NFRC 1997 Technical Interpretations

Published: March, 2004 Applicable to 1997 Procedures

National Fenestration
Rating Council

TI-2003-16 09/08/03

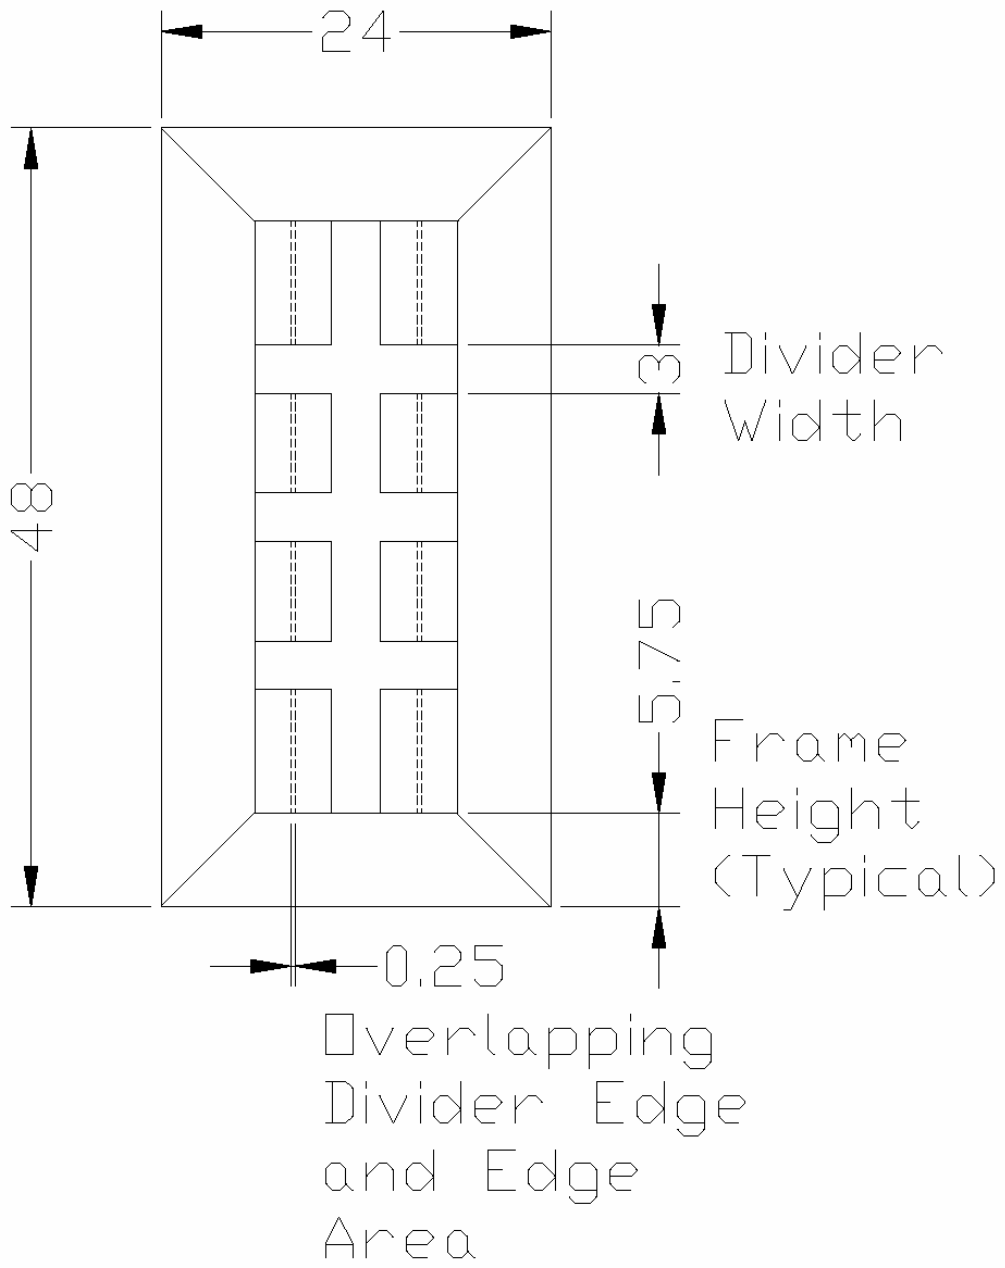
A standard window product is made with and without dividers. The dividers must be modeled in accordance with NFRC 100, but the default divider pattern does not allow for the full 63.5mm of edge-of-glass (divider) to be modeled. How should this product be area-weighted? (See attached drawing)

This interpretation shall apply to all fenestration products.

Increase the overall dimension(s) by the distance of the overlap, thereby restoring the 63.5mm edge and divider-edge dimensions, leaving the center-of-glass area equal to zero.

Note: This would be the same as the interpretation for transoms and sidelites (TI-100-99008)

NFRC TI-2003-18 (Rescinded 03-23-04)
 Equal and Unequal Sash Grouping

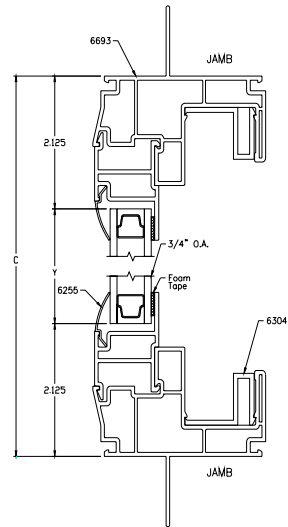
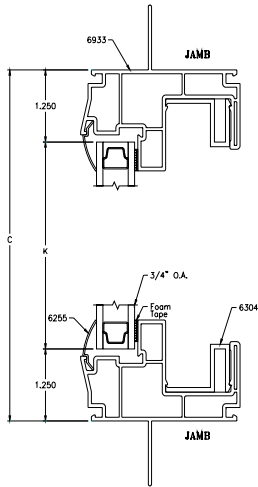
1997 Procedure Only
Can equal and unequal sash configurations be grouped as individual options in a single product line? (See attached drawings)

Yes, as long as the total product U-factor when simulated with the lowest center-of-glazing option, result in an overall product U-factor change of +/- 0.06 W/(m²K) (0.01 Btu/h•ft²•F) or less.
